To: T10 SAS Protocol Working Group

Subject: SAS 2.+ : 08-249 Link Layer Power Management

This proposal is a complement to 08-015. This proposal focusses on link layer changes to support lower power modes.

Figure 118 — SL (link layer for SAS logical phys) state machines (part 1)

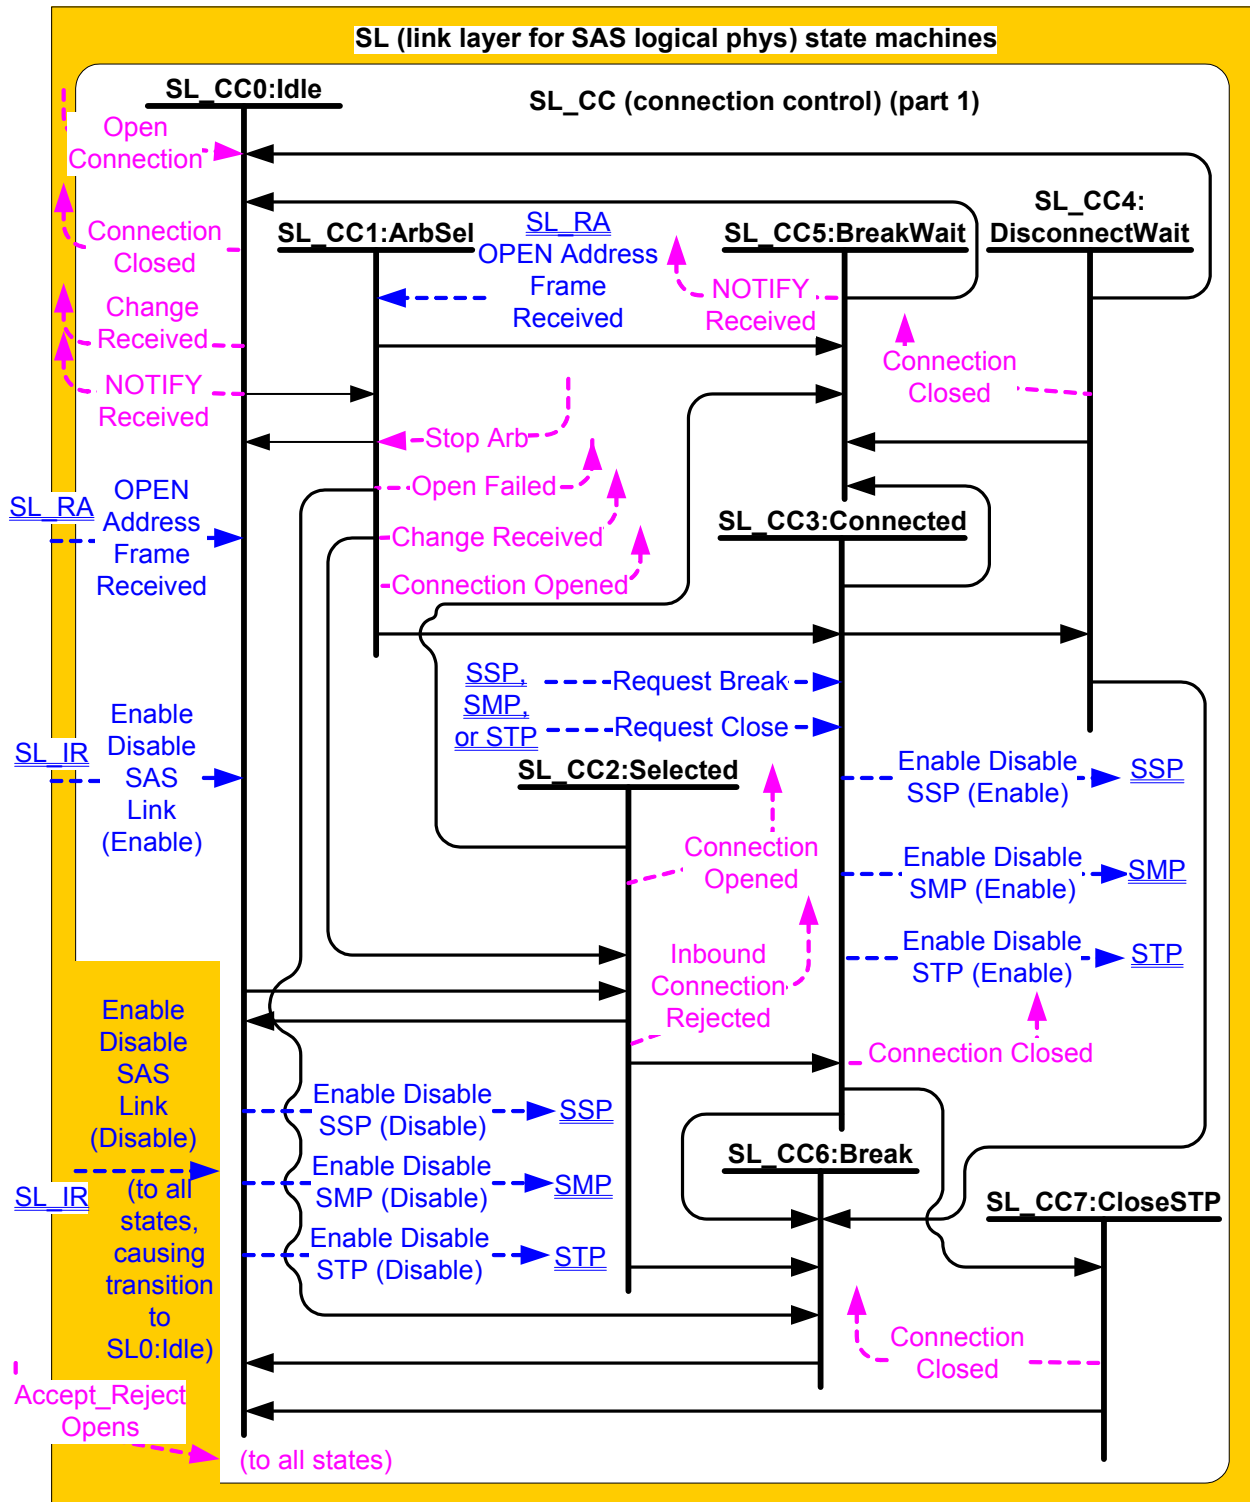
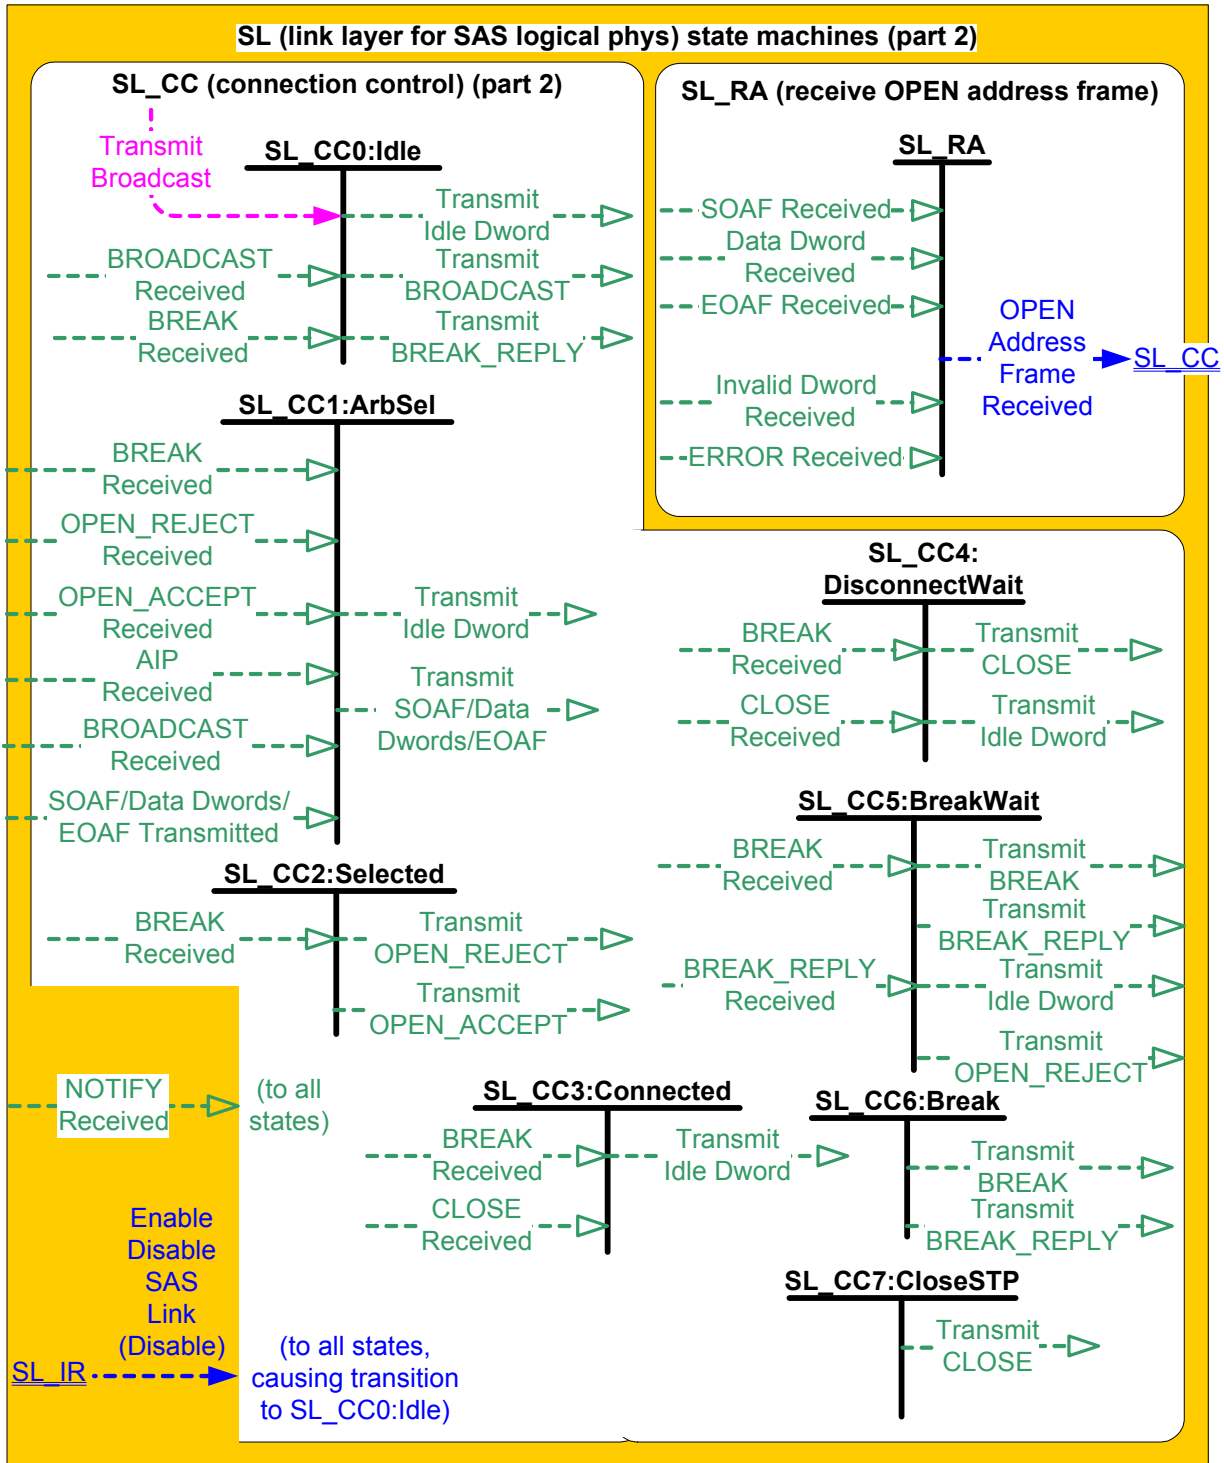
[Editor's Note 0: Need to update figures with new states, and with Request Power Management request coming down, and Phy Power confirmation coming up.](#)

Figure 120 — XL (link layer for expander logical phys) state machine (part 1)

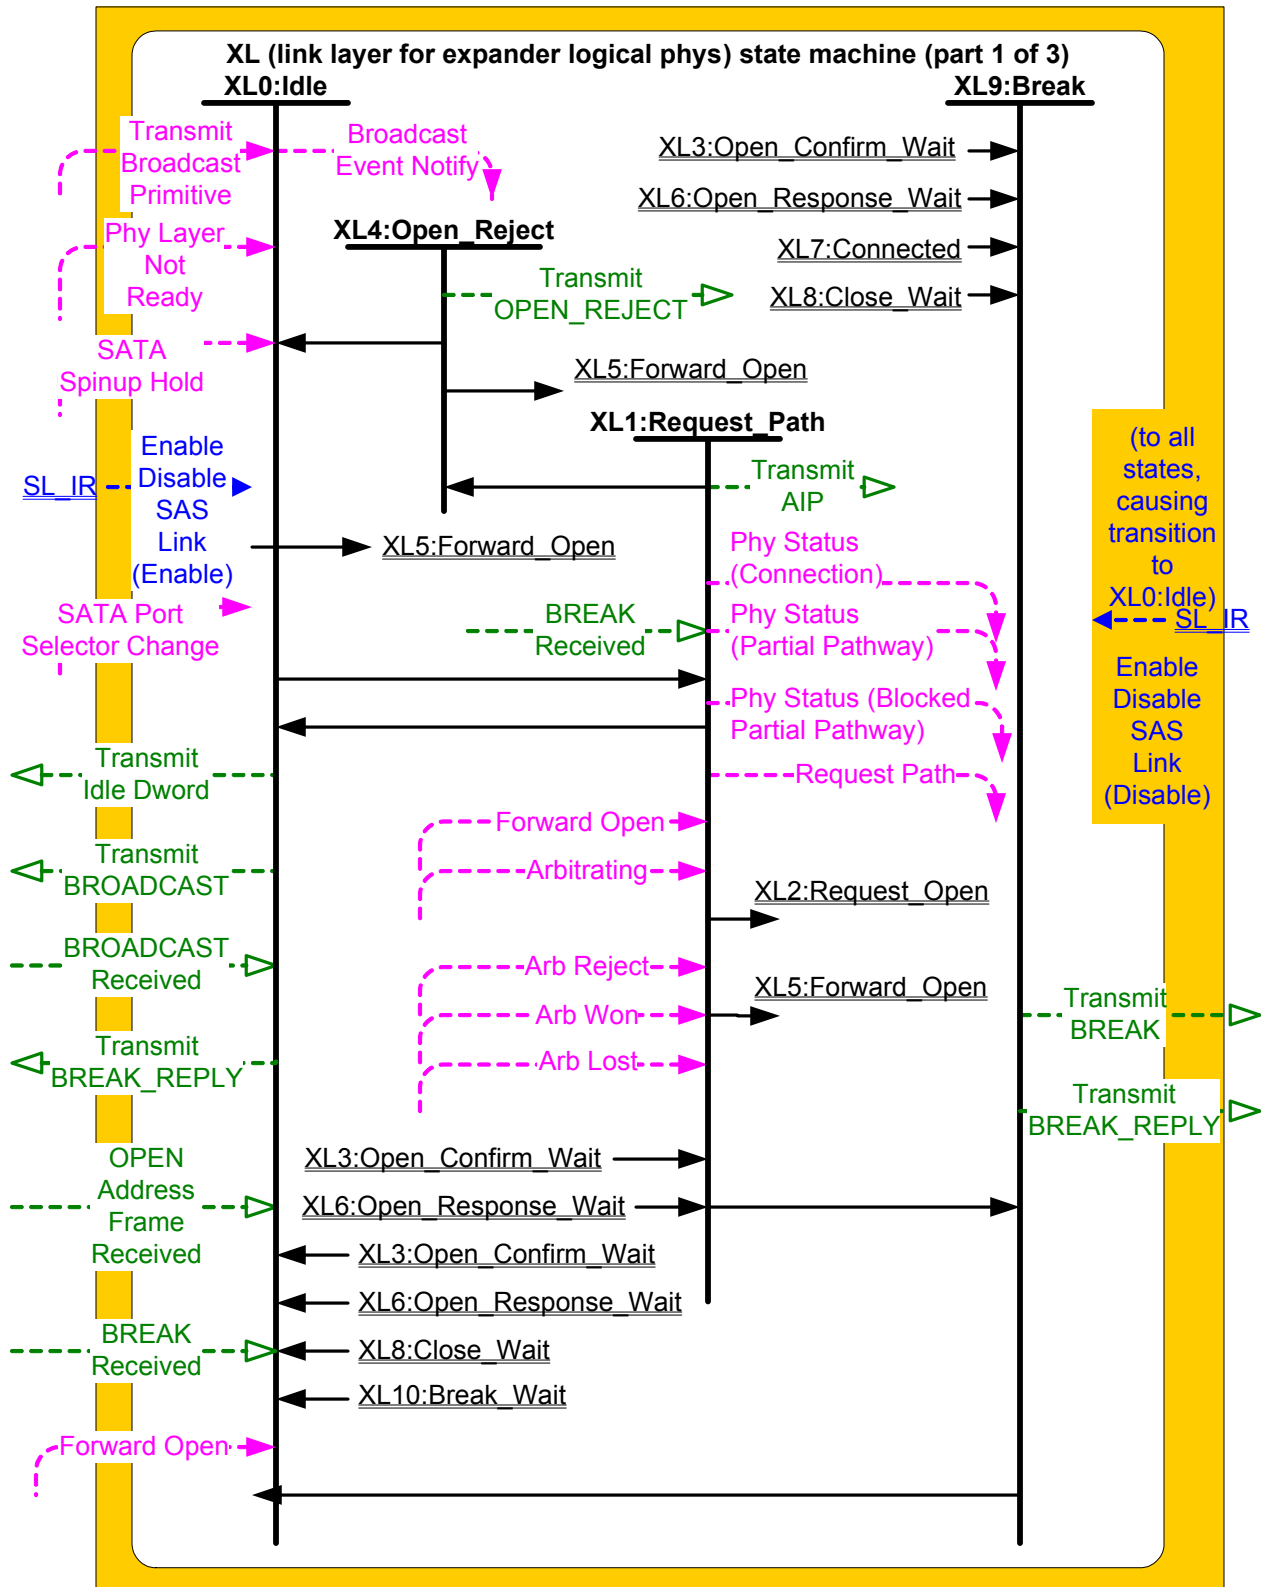
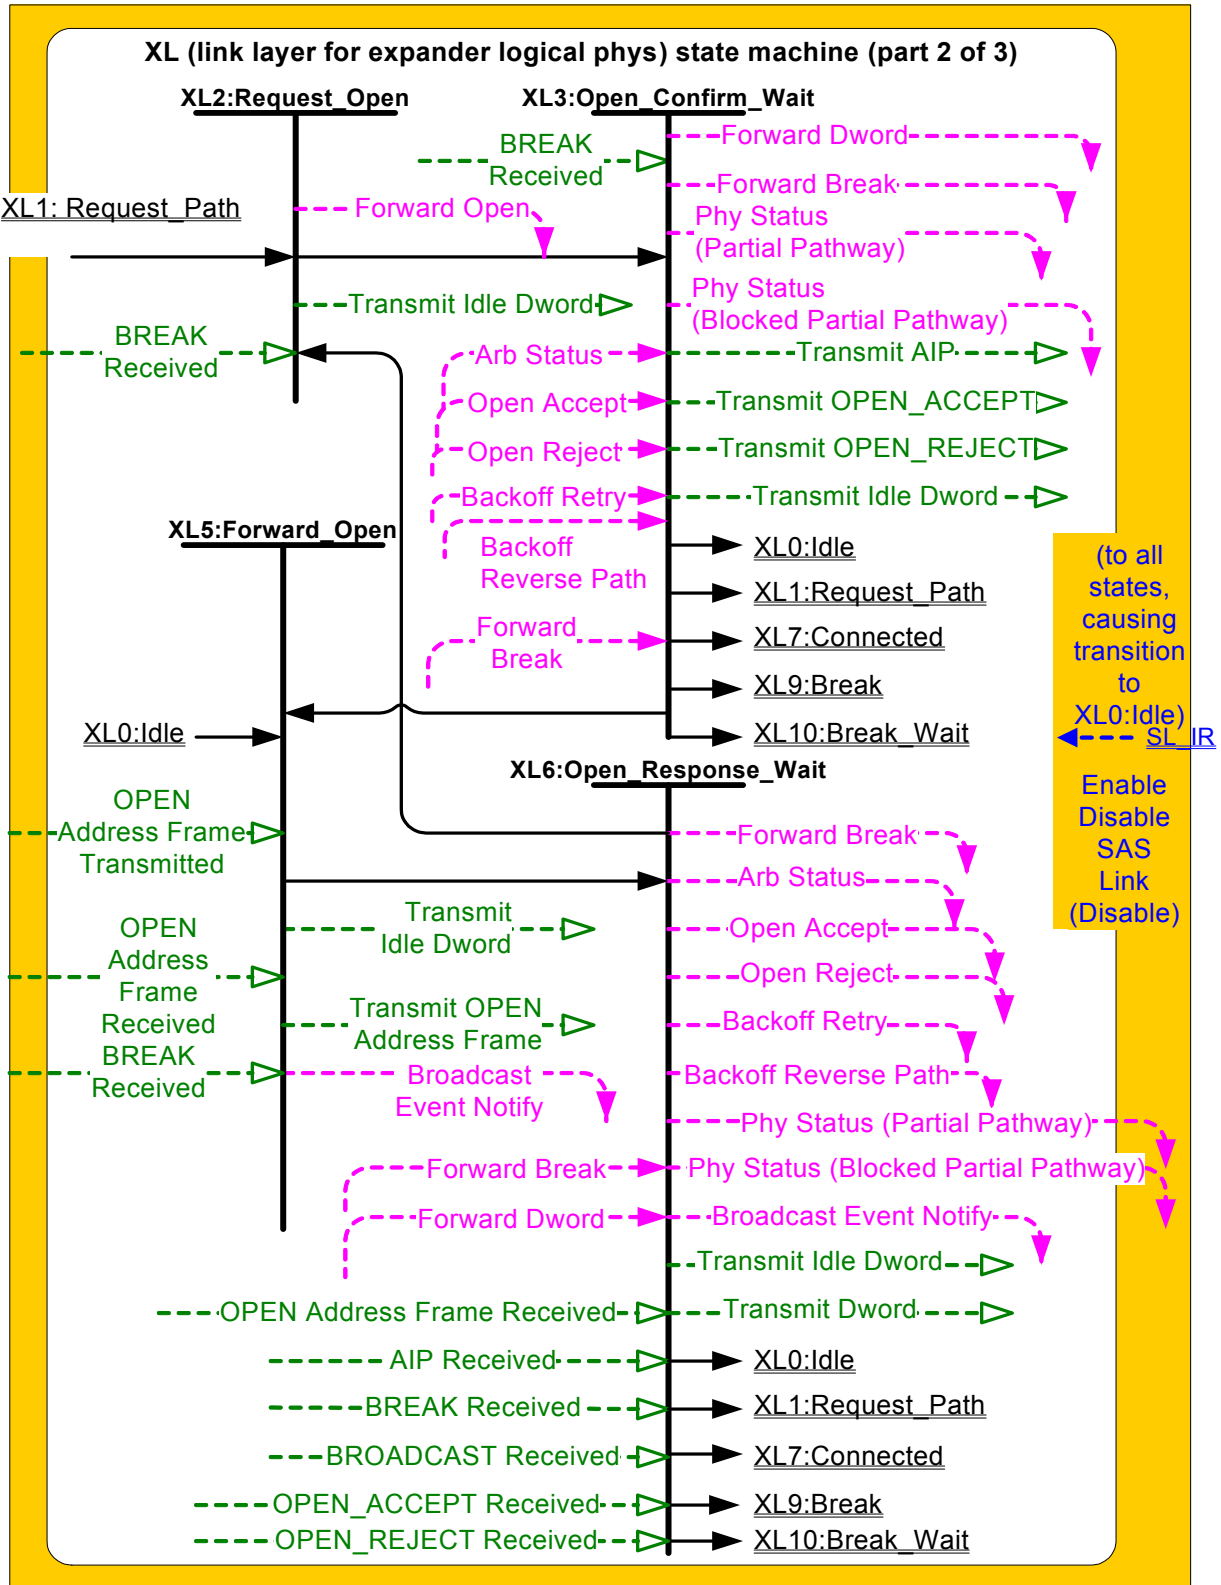
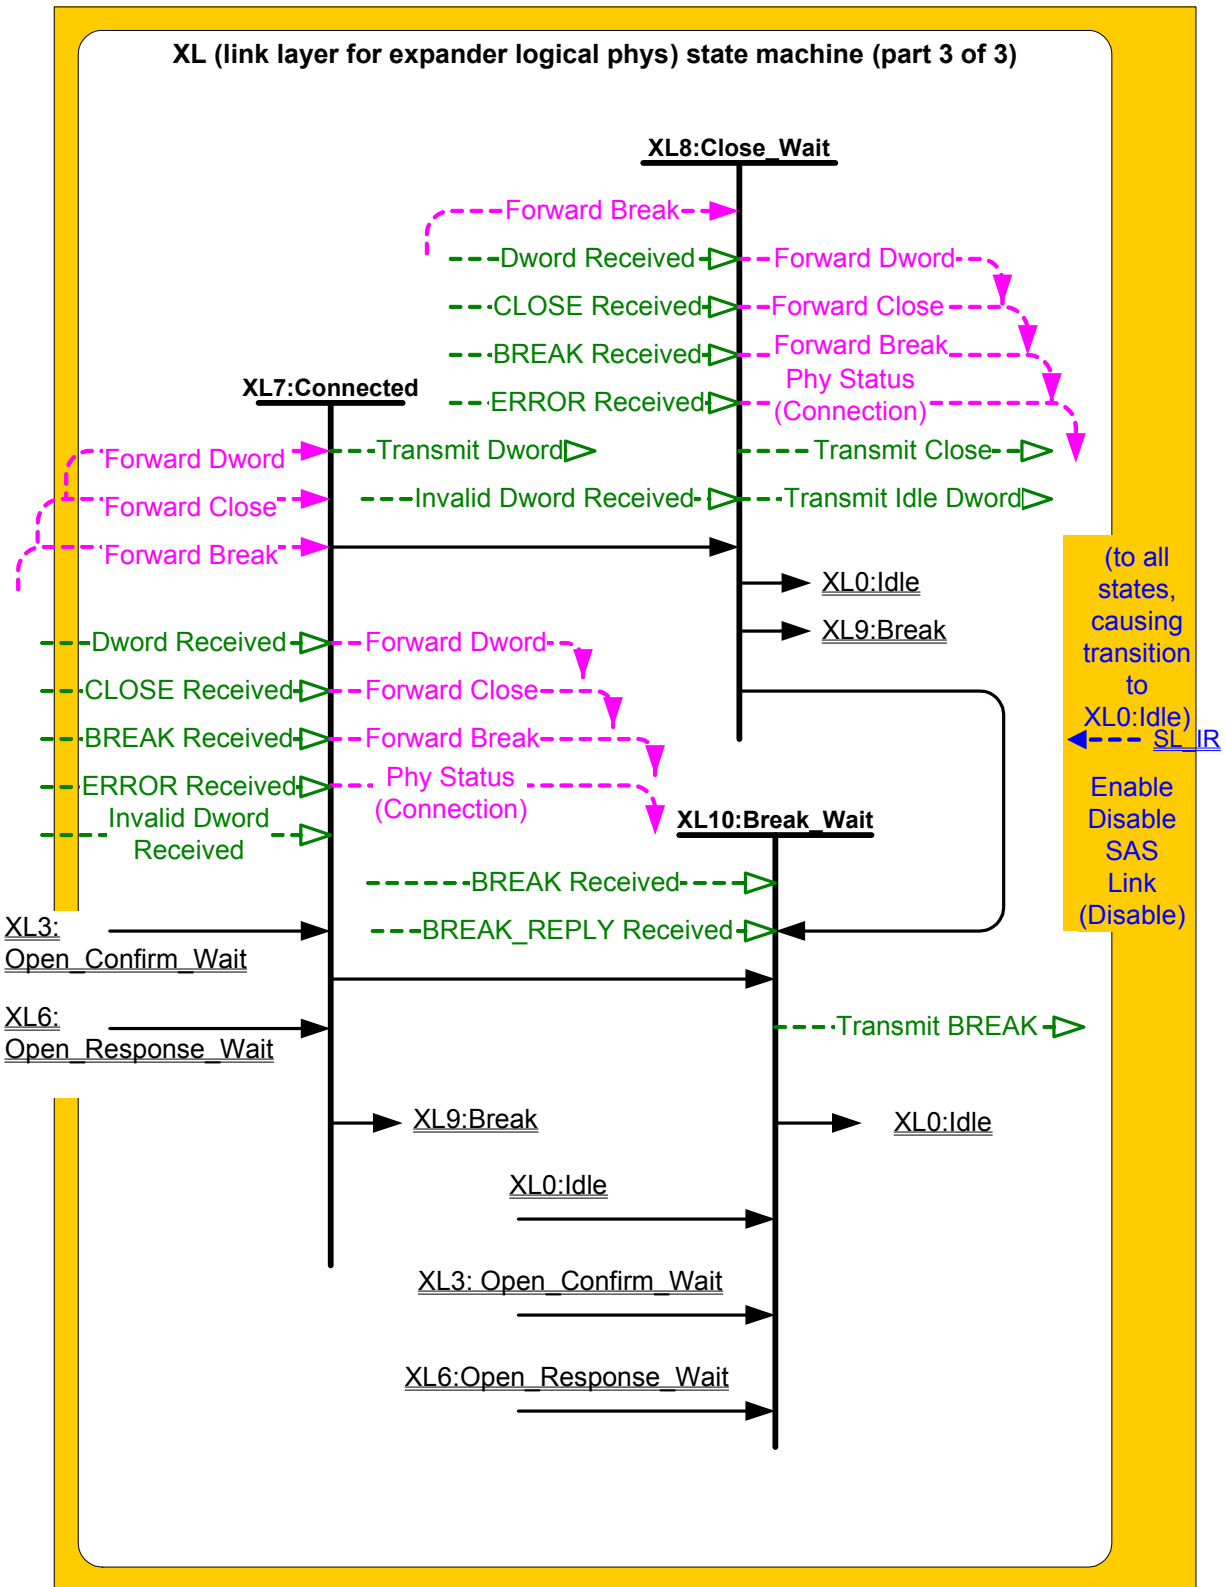
Editor's Note 10: Need to update figures with new states, and with Request Power Management request coming down, and Phy Power confirmation coming up.
